**Assessment of Eight (8) Protected-Size Trees
At and Adjacent to
94 Hernandez
Los Gatos, California**

Prepared for:
Ms. Jocelyn Shoopman, Senior Planner
Town of Los Gatos Community Development Department
110 E. Main Street
Los Gatos, CA 95030

Field Visit:
Walter Levison, Contract Town Arborist (CTA)
12/16/2024

Report by CTA
Iteration 12/22/2024 R1

12.0 Embedded: Tree Location & Protection Fence Map Mark-up

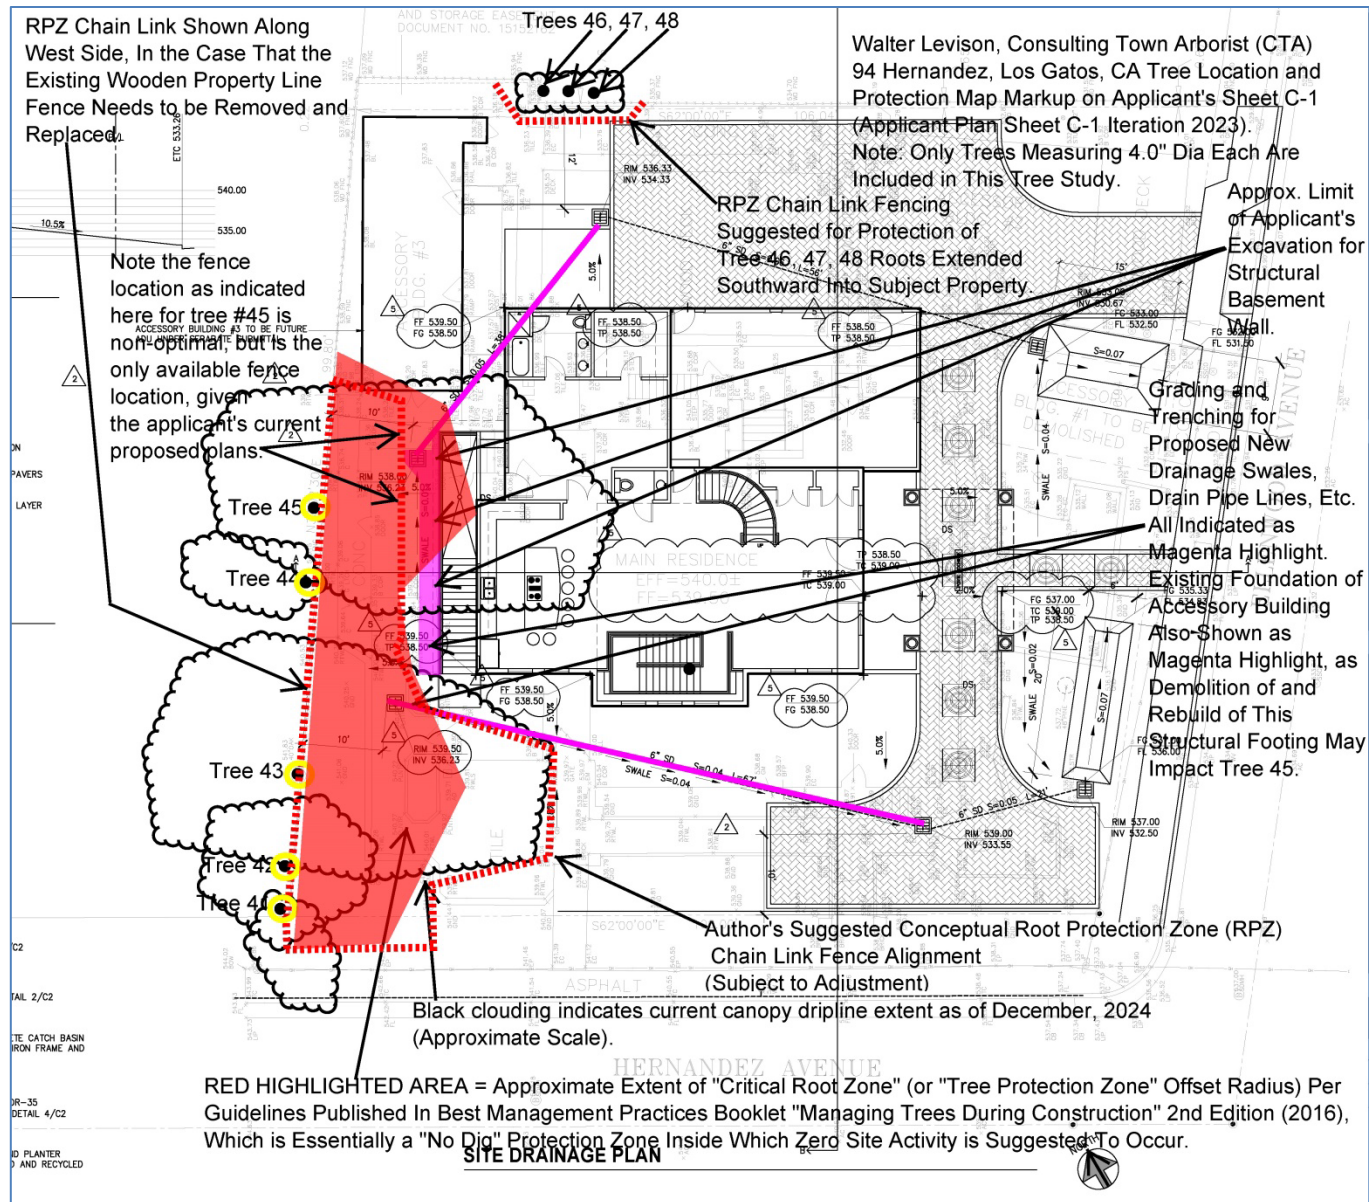
The Critical Root Zone (CRZ) of trees #43 and #45 are 19 feet radius and 18 feet radius offset from mainstem edges, respectively, which means that chain link tree root zone protection fencing (RPZ fencing) needs to be set up per the tree map markup by the CTA attached to this arborist report.

Note however that the CRZ of tree #45 shown as red highlighting on the tree map markup actually extends eastward beyond the applicant's proposed structural wall, where excavation for the basement cavity will occur, which means that the root system of tree #45 will be severed (destroyed) at an offset radius distance from mainstem somewhat shorter than the suggested CRTZ offset radius distance of 18 feet from mainstem.

- Tree #43 (Off-site Large Protected Tree): Consider adjusting the location of the proposed new storm drain inlet box and storm drain pipe trench to farther eastward than currently proposed on the applicant plan sheets, in order to allow for protective fencing to be erected along the red dashed line indicated on the CTA tree map markup.

- Tree #45 (Off-site Large Protected Tree):
 - STRUCTURAL BASEMENT WALL: Consider adjusting the proposed building footprint farther eastward to push the proposed structural basement wall farther eastward than currently proposed on applicant plan sheets (optional).

- STORM DRAIN SYSTEM: Consider adjusting the proposed new graded swale to farther offset from mainstem to allow fencing to be erected as far as possible offset from mainstem (optional).

- CANOPY VS. BUILDING EXTERIOR ELEVATIONS: Consider adjusting the proposed new residence exterior wall location facing this tree which is currently proposed as a 22 foot height massing, with a finish roof peak of 22+ feet elevation above grade (optional). It is not clear whether any adjustment of the proposed massing could reduce the “severe” degree of clearance pruning of the eastmost 25 feet of canopy mass down to a “minimal” degree of pruning, since the canopy overhangs some 25 feet length of new residence massing.

- LANDSCAPE PLANTINGS AND IRRIGATION PIPE TRENCHING: Verify that all landscape plant and tree installation irrigation systems to be installed within the tree #45 “Critical Root Zone” of 18 feet radius from mainstem will be on-grade “floating” drip emitter systems and/or bubbler systems set on top of grade to avoid irrigation pipe deep trenching impacts to the tree root zone. This type of minimal impact floating irrigation system needs to be used for the entire length of the oak tree #41, 42, 43, 44, 45 critical root zone (CRZ) area, which is the entire west side of the property shown as red highlight on the CTA’s tree map markup.

2a. Basement structural wall east of **tree #45**. Staff may want to discuss optional adjustment of basement structural wall location to push proposed excavation farther eastward to outside critical root zone of tree #45 which is indicated on the CTA's map as a red highlighted area. It is not known whether adjustment of the proposed basement structural wall to further east of its position shown on the 2023 plan sheets is feasible.

2b. Swale east of **tree #45**. Staff may want to have applicant move or remove this drainage swale and inlet drain box, to avoid root zone damage to tree #45 root system within critical root zone which for this tree is 18 feet offset radius from mainstem edge as shown by the red highlighted area on the CTA's tree map markup.

2c. Storm drain and pipe east of **tree #43**. Staff may want to have applicant push the proposed drain inlet box and piping to outside of (east of) the critical root zone of tree #45, which is 19 feet offset radius from the mainstem edge of this tree. Note that the CTA's suggested chain link protection fencing is indicated at much farther eastward offset than the location of the applicant's current proposed location of the storm drain facility.

Per the heavy red dashed lines indicated on the tree map mark-up in the CTA's arborist report section 12.0.

The CTA marked up the applicant's grading plan sheet and converted the markup to a jpeg which is embedded in this section 12.0 below.
